May 2nd, 2022
Project No. C206-21

**RE: Final Site Plan Review – Town Memo Revisions
Terra Cotta Pasta Company (Tax Map 3, Lot 1)
52 State Road, Kittery, Maine**

**RE: Site Plan Review Application – Peer Review Revisions
Terra Cotta Pasta Company (Tax Map 3, Lot 1)
52 State Road, Kittery, Maine**

DETENTION POND #1 OUTLET STRUCTURE

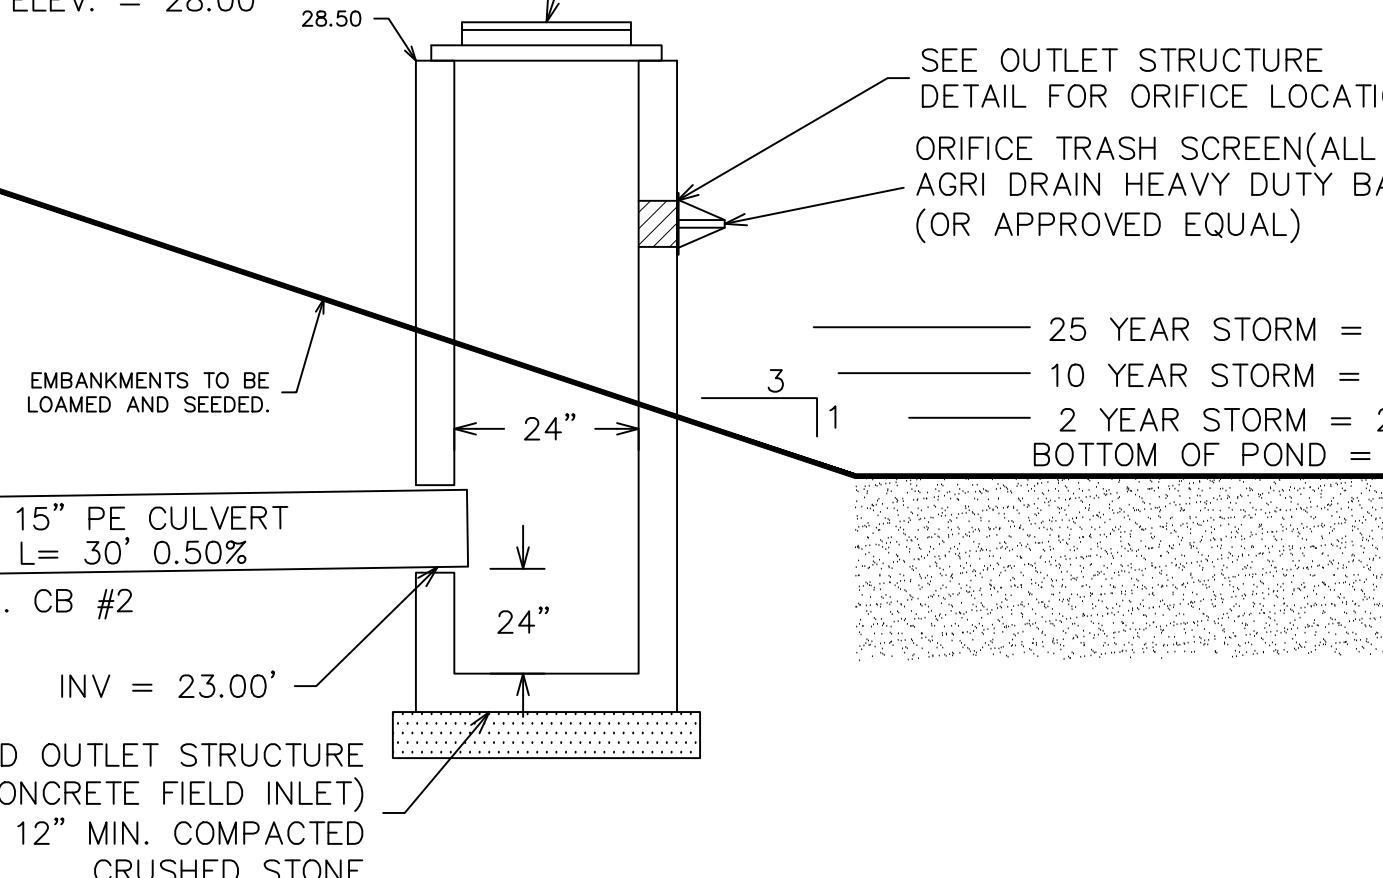
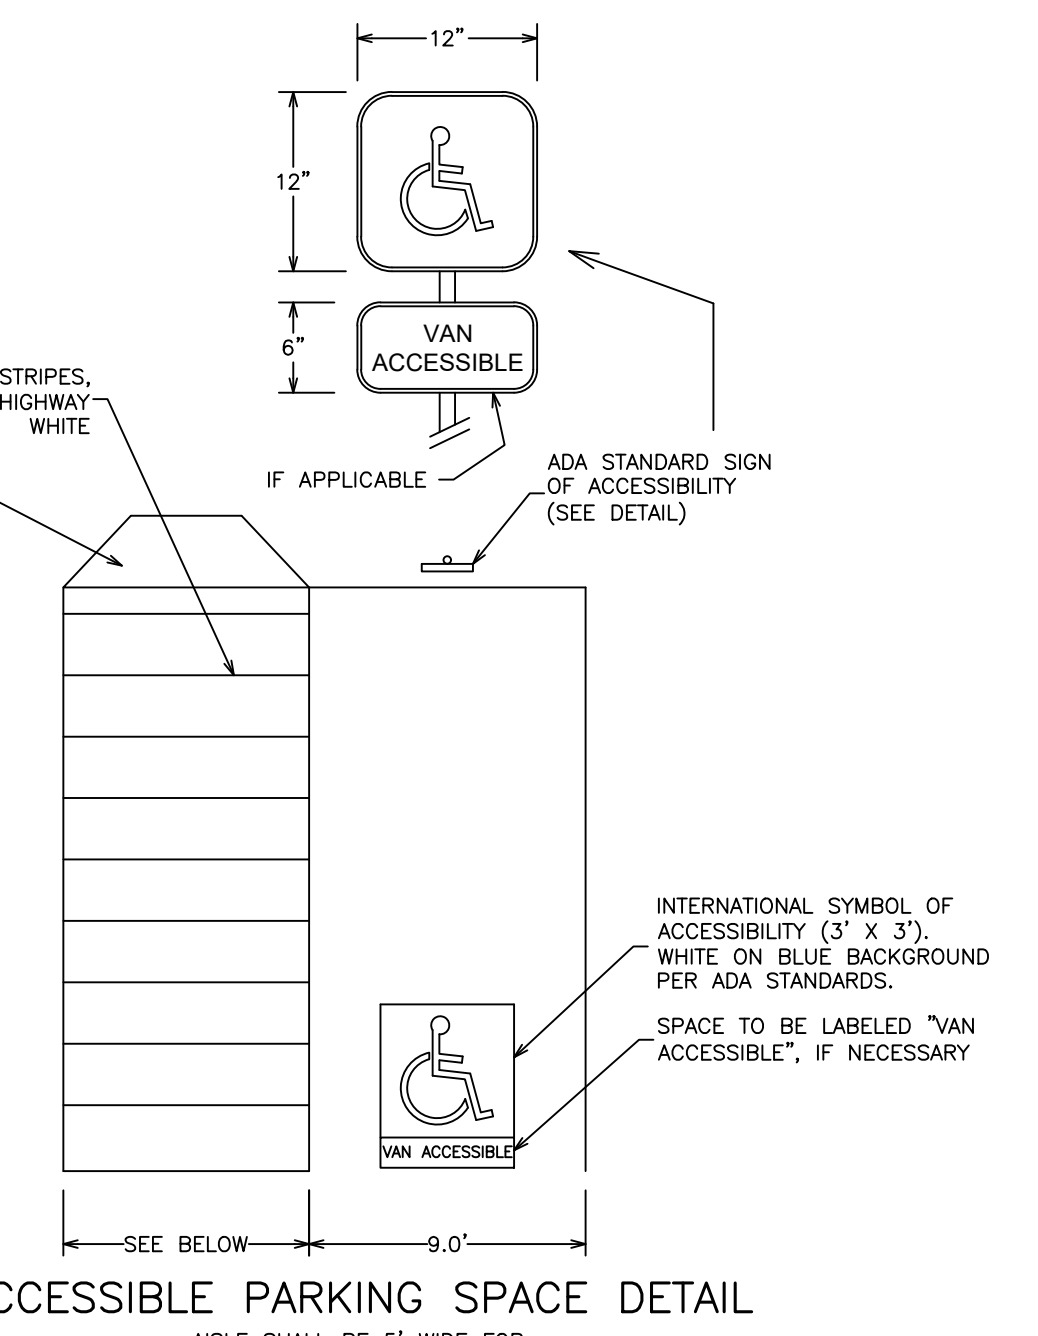
- Sheet 4 (Site Details) has been revised to include details for the proposed stormwater detention basin, as well as the outlet structure of said basin. Callouts to these details on Sheet 3 remain unchanged – the details did not reside on a plot-visible layer previously.
